GCA CORPORATION
Technology Division

U.S. Environmental Protection Agency
Region VII
324 East 11th Street
Kansas City, MO 64106

INSPECTION OF GROUND WATER
MONITORING PROGRAM
NIXDORFF-LLOYD CHAIN COMPANY
MARYVILLE, MISSOURI
EPA REGION VII

December 1984

Figure 3. GCA audit measurements of ground water elevations at RCRA monitoring wells, 9/21/84.

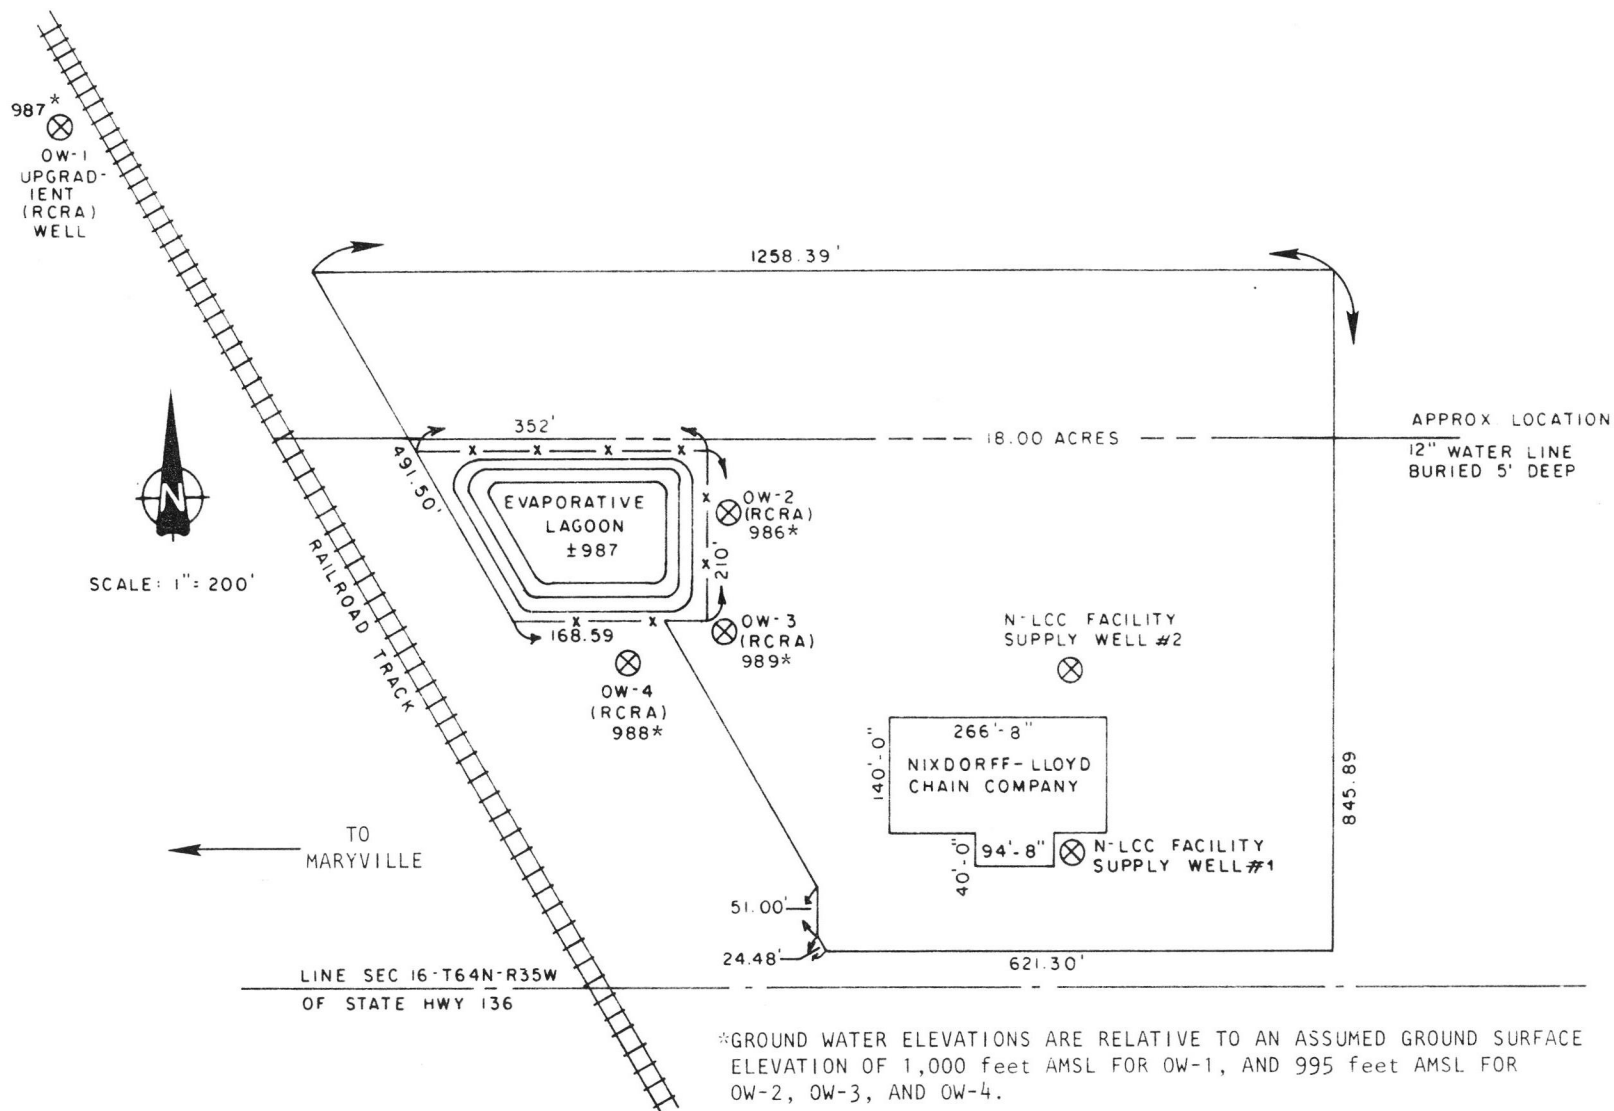
The Nixdorff-Lloyd Chain Company water supply well #2 located on the north side of the plant building is within 400 to 600 ft radius of the RCRA wells and surface impoundment (see Figure 3, Facility Plan Map). Well yields for pumping of both wells (north and south) were noted to be 25 to 50 gallons/minute each according to facility personnel and Layne-Western Co., 1970 (see Appendix A). Previous inspection reports have indicated the possibility of the pumping wells influencing drawdown in the RCRA monitoring wells.

Figure 4. Nixdorff-Lloyd Chain Company historical RCRA monitoring well pH results.

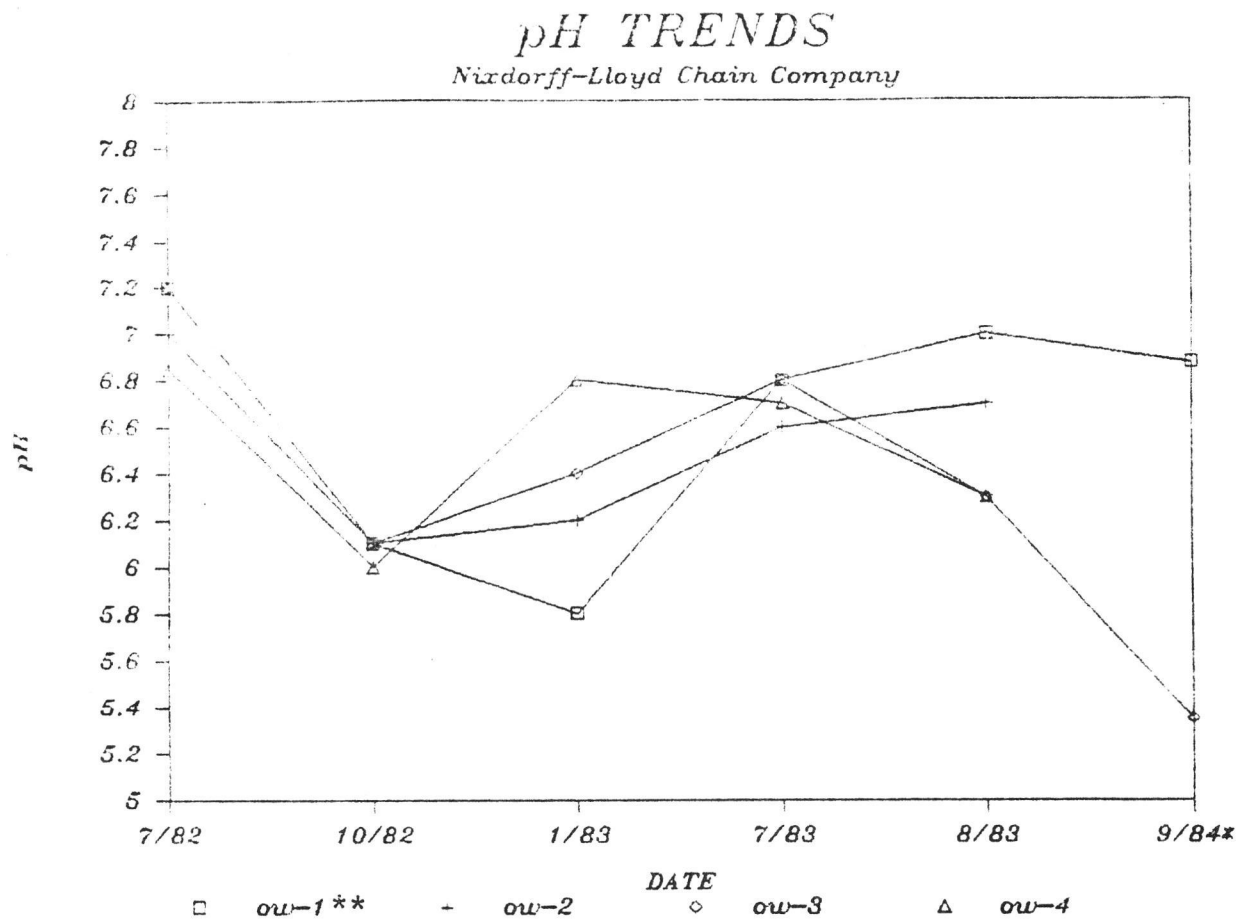
Audit measurements in comparison to July 13, 1983 data (KCTL) demonstrate a significant fluctuation of water levels in both OW-1 and OW-3, as well as conductivity. Measurements of pH were only significantly different for Well OW-3 (see Figure 4).

A review of the data available to GCA shows rather dramatic changes in monitored parameters. This is readily evident in the pH results as presented in Figure 4. Note particularly the changes that occur between July 1983 and August 1983 when OW-1 and OW-2 show an increase in pH and OW-3 and OW-4 show a decrease in pH. Similar erratic variations are evident in other parameters. This seems to further support the previously discussed contention that the wells are monitoring perched and not necessarily representative portions of the aquifer.
